# SERVICE BULLETIN

COLLINS RADIO COMPANY

EQUIPMENT TYPE KWM-1

BULLETIN NO. 1

Figure 1. Wiring Location of L1 Shield Can

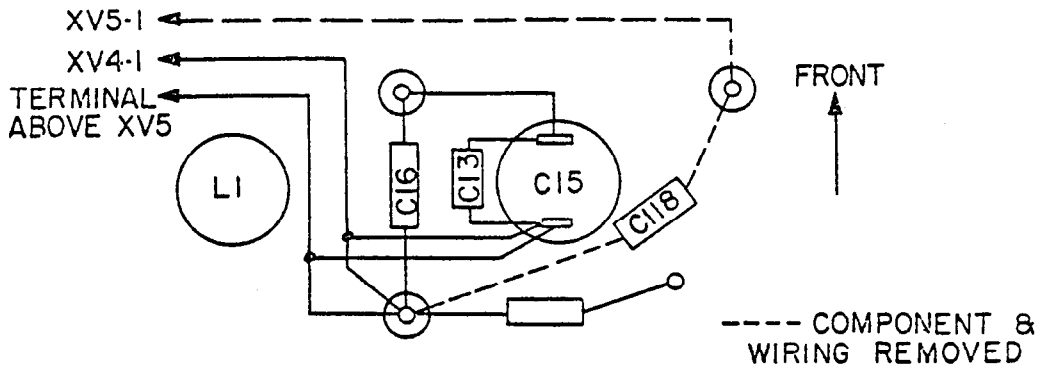
It has been noted that multiple beats are present in Calibrate position of the Emission Switch. The following modification will increase the strength of the correct calibration signal. Units using a type 6AU6 tube for V1 require this modification.

4. Remove 1 uuf capacitor, C118, and coax lead from C118 to XV1 pin 5. C118 and coax

lead are connected to insulated terminal mounted on trimmer capacitor. Discard coax and capacitor. See figure 1.

7. Install a five inch length of coax cable (425 0926 00) from terminal directly over XV5 pin 9 (installed in step 5) to insulated terminal to which C16 and coax cable to XV4 pin 1 is connected. See figure 1. Ground coax shield to C15 as shown in figure 1. Ground shield at C15 end only.

Figure 2. Location of Number 29 Hole for Installation of Insulated Terminal

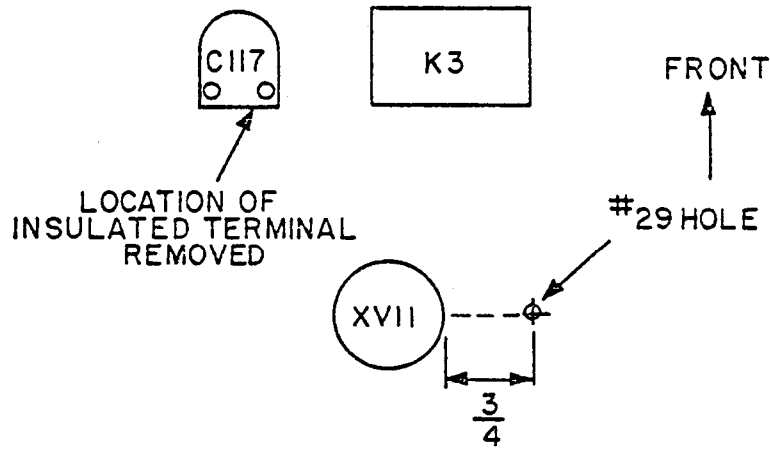
13. Unsolder .001 capacitor and coax from the insulated terminal mounted on "Cal Zero"

capacitor, C117, (insulated terminal on K3 side of capacitor) and remove insulated terminal from capacitor. See figure 2.

15. Drill new hole as indicated in figure 2. Care should be taken not to damage wiring and other components when drilling this hole.

Figure 3. Partial Schematic V1, After Modification

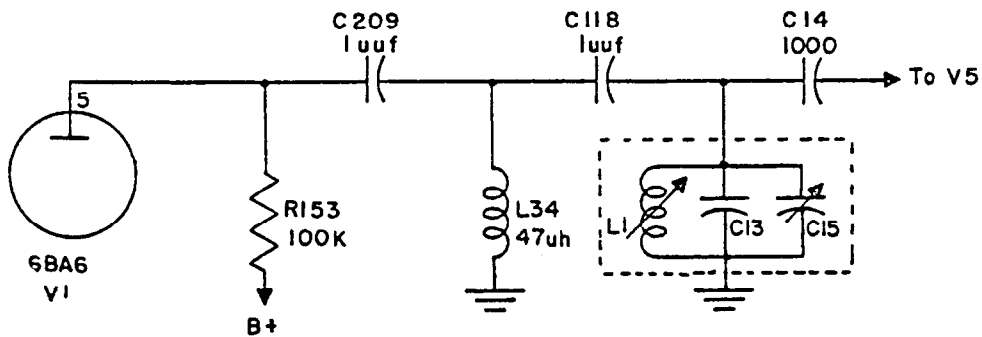
19. Check circuit for correct wiring as shown in Figure 3.

Figure 4. Location of Number 29 Hole for Installation of Insulated Terminal

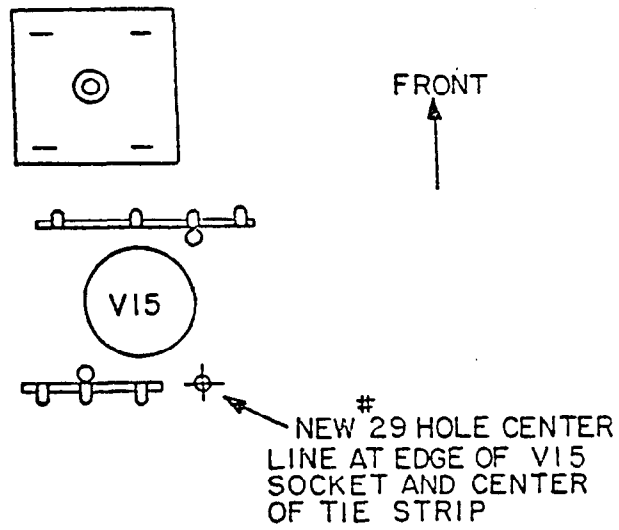
1. Remove the 330K 1/2 watt resistor, R124, connected to terminal on terminal strip behind XV12. (See Figure 6). R124 should be removed by cutting from the strip and discarded.
2. Carefully drill a number 29 hole next to tie strip at rear of XV15 as shown in figure 4. Care should be taken not to damage cable harness.
3. Mount insulated terminal (306 0233 00) in hole drilled in step 2 using 4-40 x 3/16 screw (343 0284 00).
4. Connect a new 330K resistor, R124, (745 1457 00) from center terminal of terminal strip behind XV12 to insulated terminal installed in step 3.
5. Connect 330K resistor, R156, (745 1457 00) from insulated terminal installed in step 3 to

Figure 5. Partial Schematic V15, After Modulation

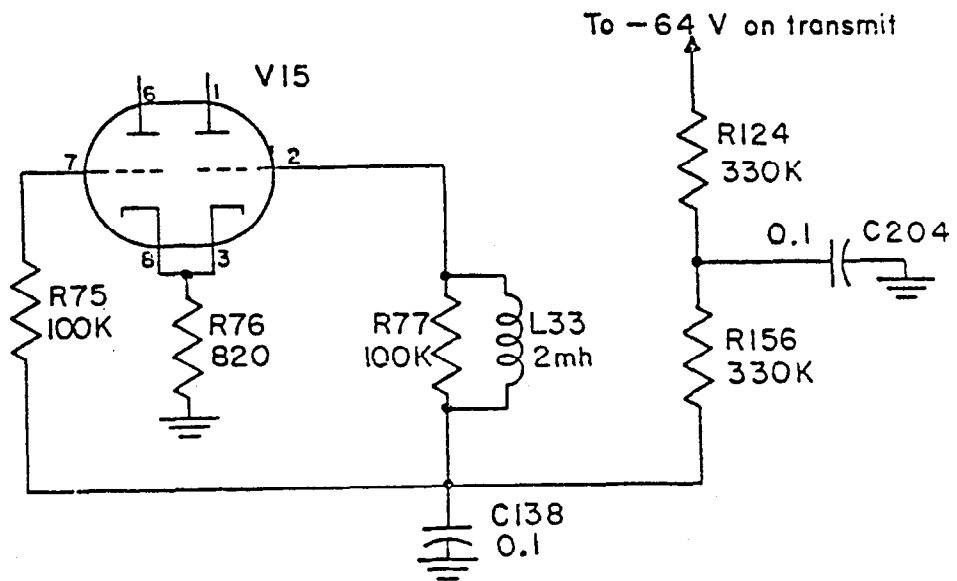
6. Connect .1 uf capacitor, C204, (931 0299 00) from insulated terminal installed in step 3 to same ground as C138. See figure 6.
7. Check XV15 pin 2 for the presence of a 2.2 mh rf choke connected across the 100K resistor connected to this pin.
8. If the choke is not present, connect a 2.2 mf choke (240 0084 00) across the 100K resistor, R77, connected to pin 2 of XV15.
9. Refer to figure 5 for schematic of completed modification.

Figure 6. Location of Components, Bottom View

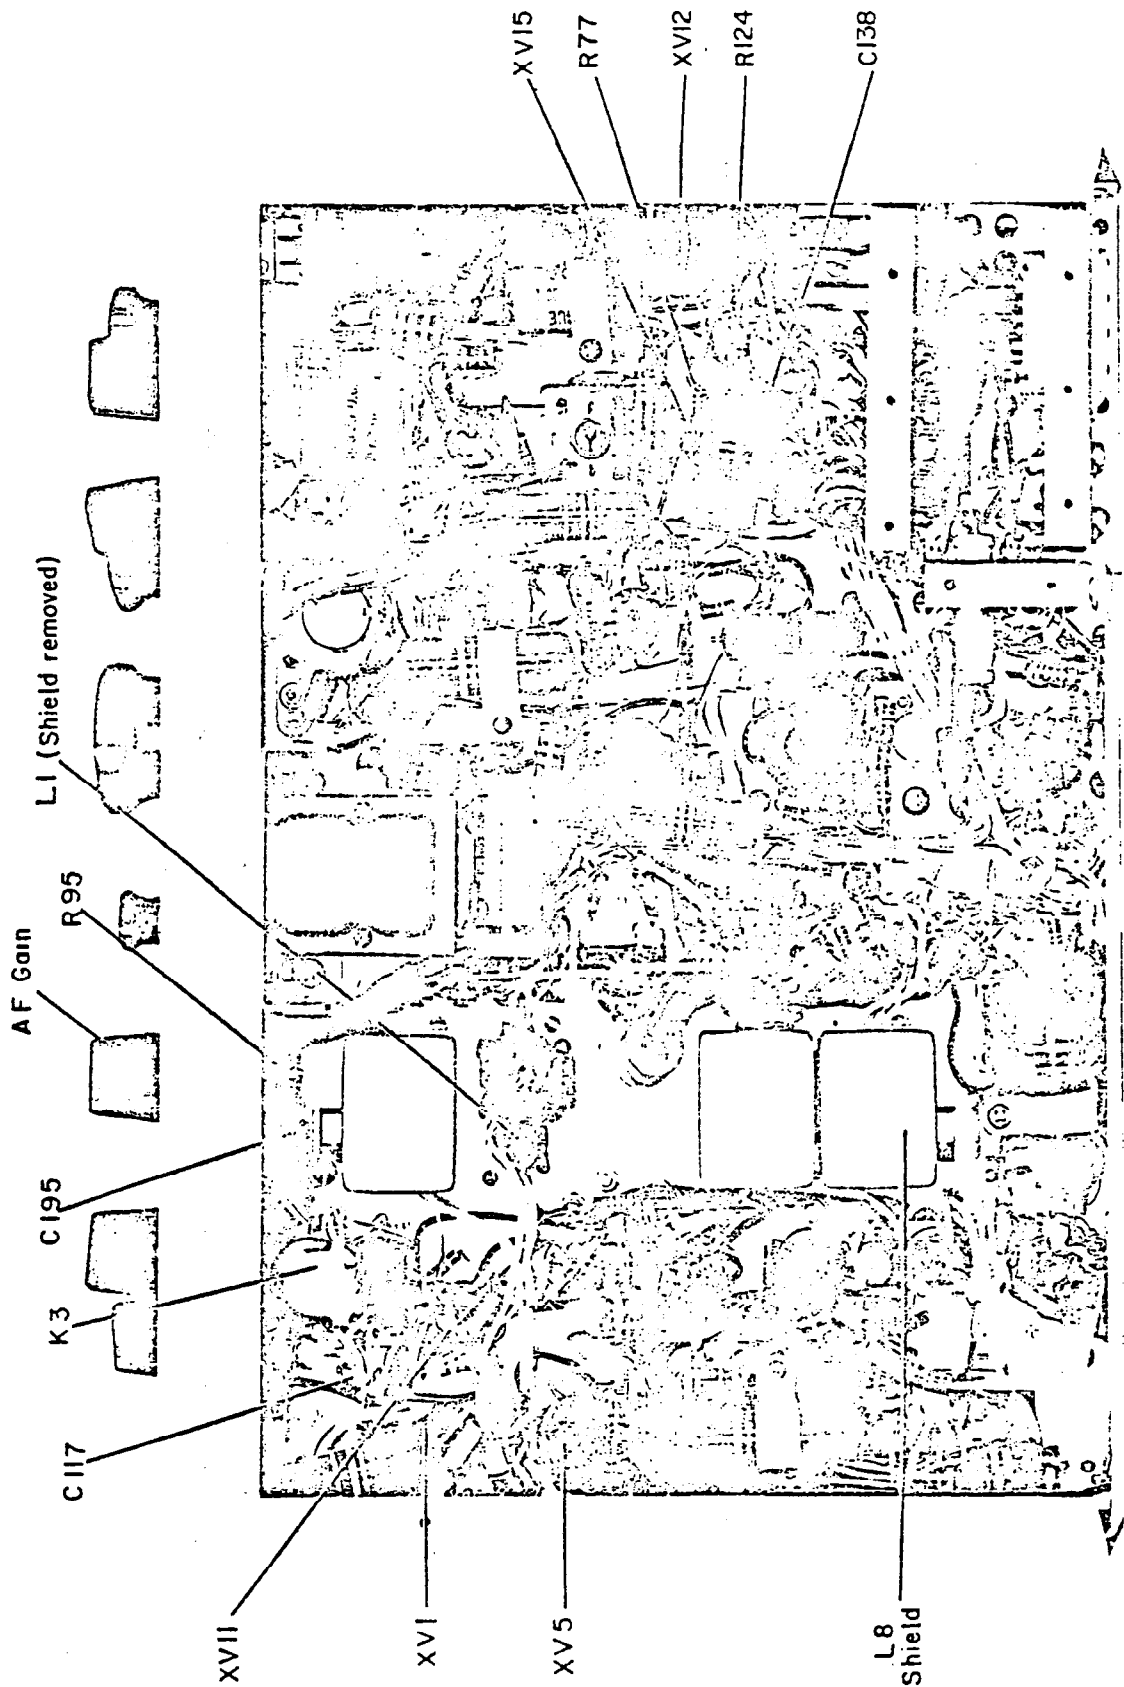
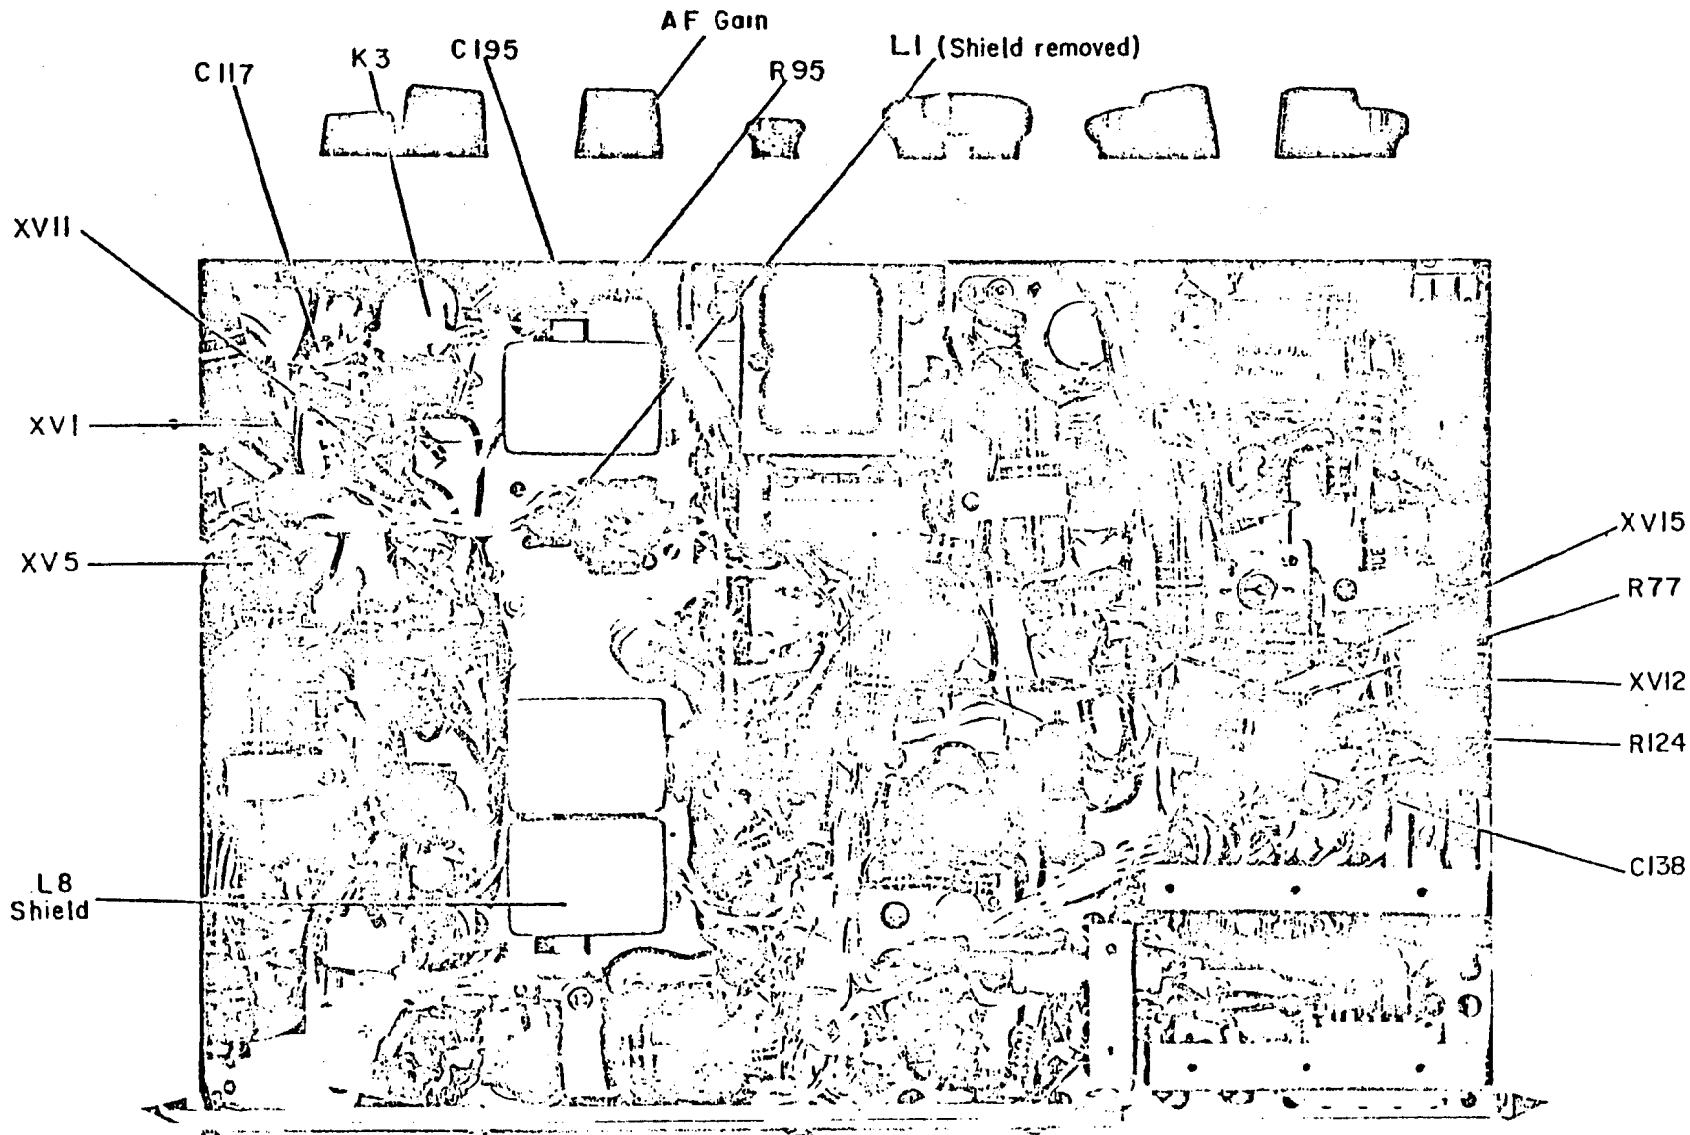
3. Remove L1 coil can. (L1 can is located beside XV4 and is second can nearest front of the unit). See figure 6.

1. Remove the L8 shield can. See figure 6.
2. Install five ground clips (220 1323 00) around edge of the can and replace in original location. Make sure that can mounting nuts are tight.

In earlier models of the KWM-1, some hum could be heard if the AF Gain control was run high when in CW operation. This is actually a low frequency oscillation in the sidetone circuit and may be eliminated by the following modification. Units that have this modification installed will have a four terminal tie strip mounted directly behind the RF and AF gain controls with a 470 K 1/2 watt resistor connected in series with a 220 uuf capacitor mounted on the strip. Figure 6 shows the modified circuit.
